Access Compliance Report

Public Rights-of-Way

Intersection ID: 42947	Main Street: MOONDANCE_LN	Cross Street: SEBASTIANI_DR	Location: SE
ADA ID: 1D9C9215EA90	Ramp Type: PerpDiag	Initial Pass/Fail: Fail	Overall Compliance: No
		Severity Score: 10

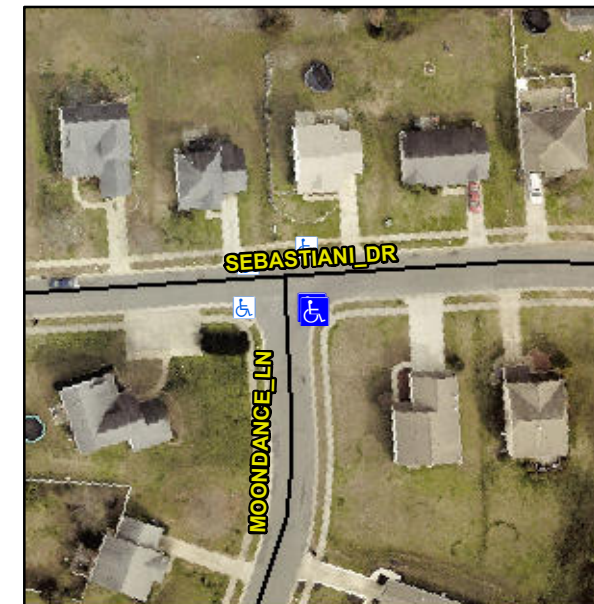
Not Found, R304.5.1, R304.5.3

Compliance	Description	Data	Compliance	Description	Data
N/A	Ramp Length (in)	48.0	Yes	Ramp Slope (%)	6.4
No	Ramp Width (in)	42.0	No	Ramp XSlope (%)	3.8
N/A	Flare Type LT	N/A	N/A	Flare Type RT	N/A
N/A	Flare Slope LT (%)	N/A	N/A	Flare Slope RT (%)	N/A
N/A	Flare Traversable LT?	N/A	N/A	Flare Traversable RT?	N/A
N/A	Landing Length (in)	N/A	N/A	DWS Provided?	N/A
N/A	Landing Width (in)	N/A	N/A	DWS Contrast?	N/A
N/A	Landing Slope (%)	N/A	N/A	DWS Length (in)	N/A
N/A	Landing X Slope (%)	N/A	N/A	DWS Full Width?	N/A
N/A	Landing Curb? (Y/N)	N/A	N/A	DWS Offset (in)	N/A
N/A	Shared Landing?	N/A			
N/A	Gutter Ponding?	N/A	N/A	Gutter Slope (%)	N/A
N/A	Gutter Lip Ht (in)	N/A	N/A	Gutter X Slope (%)	N/A
N/A	Painted X Walk1?	No	N/A	Painted X Walk2?	No
	X Walk 1 Direction	To N		X Walk 2 Direction	To W
N/A	X Walk 1 Width (in)	N/A	N/A	X Walk 2 Width (in)	N/A
	X Walk 1 Slope (%)	5.2		X Walk 2 Slope (%)	0.2
	X Walk 1 X Slope (%)	3.2		X Walk 2 X Slope (%)	4.8

Remove & Replace Curb Ramp With Two New Directional Ramps or Equivalent.
